Project/Property Address or Location: 1041 North Hamilton Road		Project Name/Business Name (if applicable): The Shops at Oberer's Crossing	
Parcel ID No.(s): 025-009953	Current Zoning: PCC	Total Acreage: 5.19	
Project Description: Neighborhood service retail, office and restaurant in three buildings located at the southwest corner of Beecher Road and North Hamilton Road.			
APPLICANT Name (primary contact) -do not use a business name: Academy Development Limited Partnership		Applicant Address: 107 S. High Street, Suite 300, Columbus, OH 43215	
Applicant E-mail: jsugar@arshot.com		Applicant Phone No.: 614-463-9730	
BUSINESS Name (if applicable):			
ATTORNEY/AGENT Name: Glen A. Dugger, Smith & Hale LLC		Attorney/Agent Address: 37 W. Broad Street, Columbus, OH 43215	
Attorney/Agent E-Mail: gdugger@smithandhale.com		Attorney/Agent Phone No.: 614-221-4255	
ADDITIONAL CONTACTS (please list all applicable contacts)

THE SHOPS AT OBERER'S CROSSING

Project 1041 N. Hamilton Rd. Final Development Plan Responses to comments dated December 18, 2017

C100

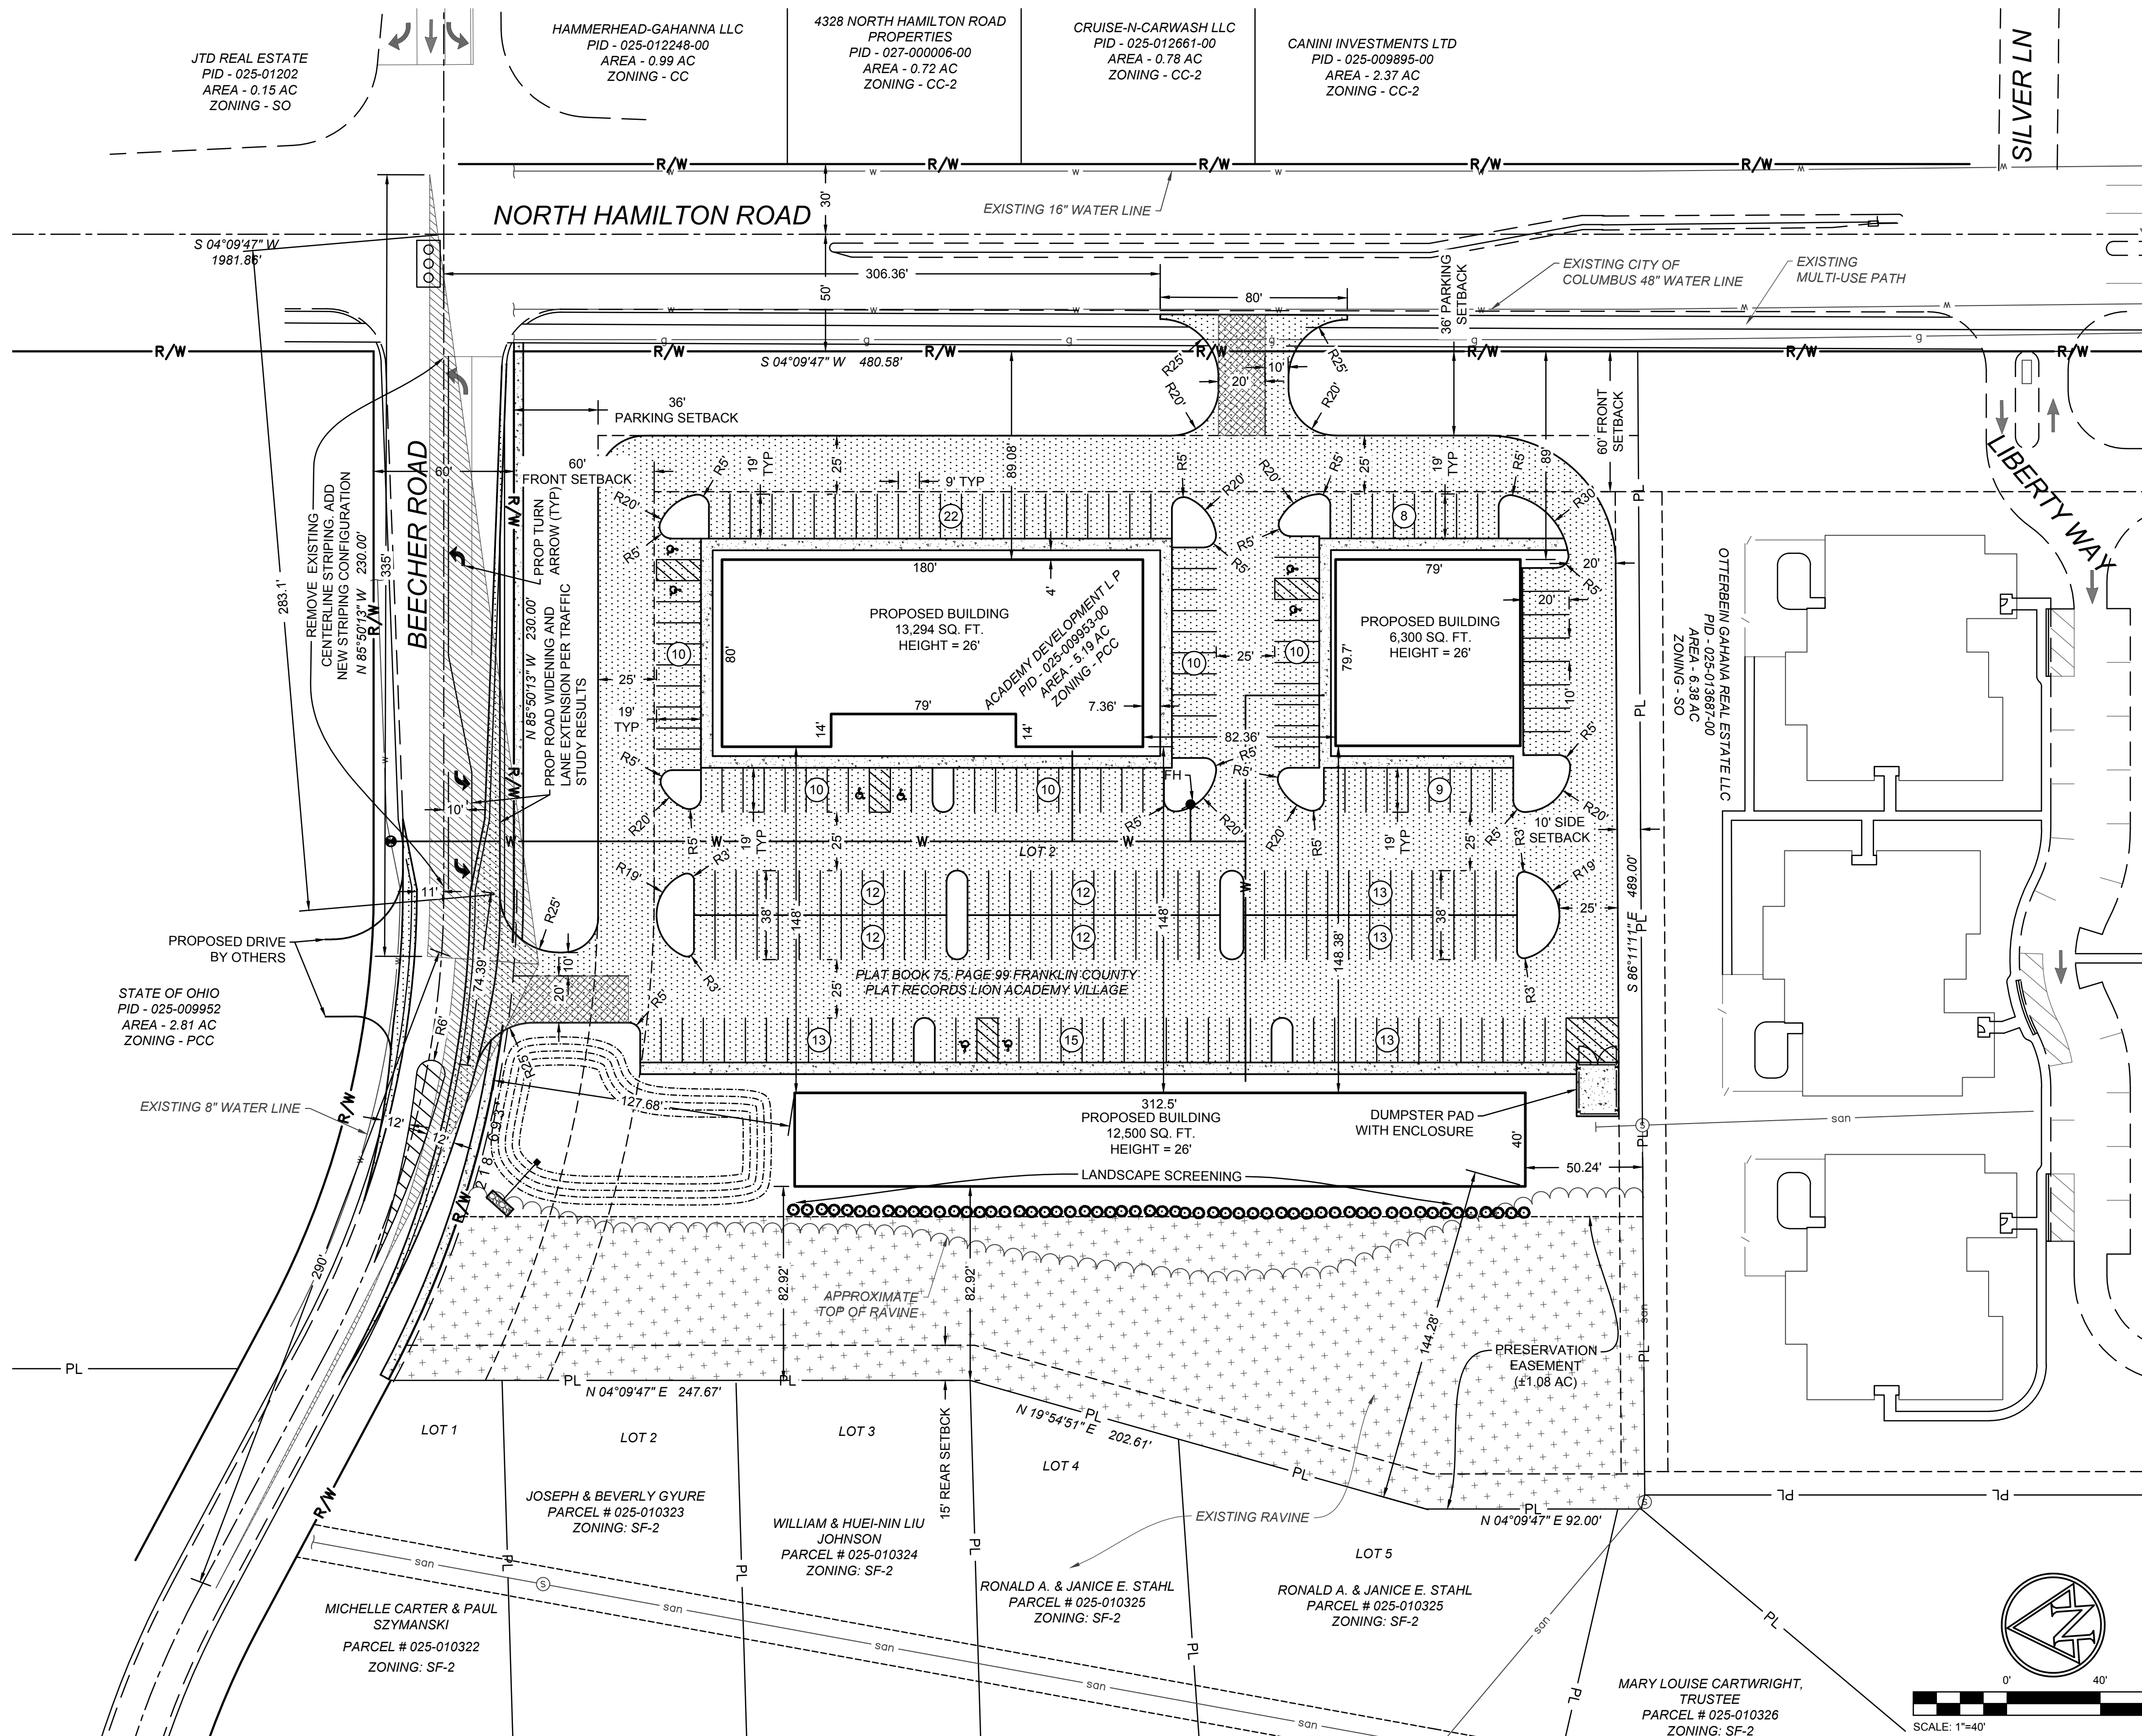
4. **Comment** – The proposed main entrance shall have an unobstructed ingress width of not less than 20 feet for fire apparatus access in accordance with Section 503.2 of the 2011 Ohio Fire Code. The roadway around the development is of adequate width. The roadways shall be constructed of heavy duty pavement to support a 75,000-lb. fire apparatus. See attached tables and Fire Codes per Steve Welsh

- (b) Two access drives are shown for the project.
- (c) Access management is a goal of our office to restrict the number of access locations along major thoroughfares to help reduce the potential for collisions. At this time, our office will permit one right-in/right-out access to Hamilton Road for this parcel.

- (d) A full access drive will be considered on Beecher Road, pending the update and final review of the Traffic Impact Study. A minor widening of Beecher Road will be required through the proposed drive on Beecher Road to accommodate a future left turn lane on Beecher Road for the property located on the south side of Beecher Road. The full extent of this widening shall be shown on the final development plan.

- (e) Please verify that the adequate intersection sight distance is provided for the proposed access location on Beecher Road.
- (f) Sidewalk and or multi-use trail shall be constructed, re-constructed and or maintained along the entire frontage of the development.

Response – Complete. FDP shows main entrance with a width of 25 feet. Roadways will be constructed per code.

- (a) Complete. The traffic impact study has been updated and submitted.
- (b-d) Complete. The FDP shows one full-service access on Beecher Rd. and one right-in/out access on Hamilton Rd. A minor widening of Beecher Rd. is also shown, as necessary to accommodate a future left turn lane.
- (e) Complete. Adequate intersection sight distance is provided for Beecher Rd. access.
- (f) Complete. Sidewalk and multi-use trail will be maintained and/or constructed along frontage as shown on FDP.
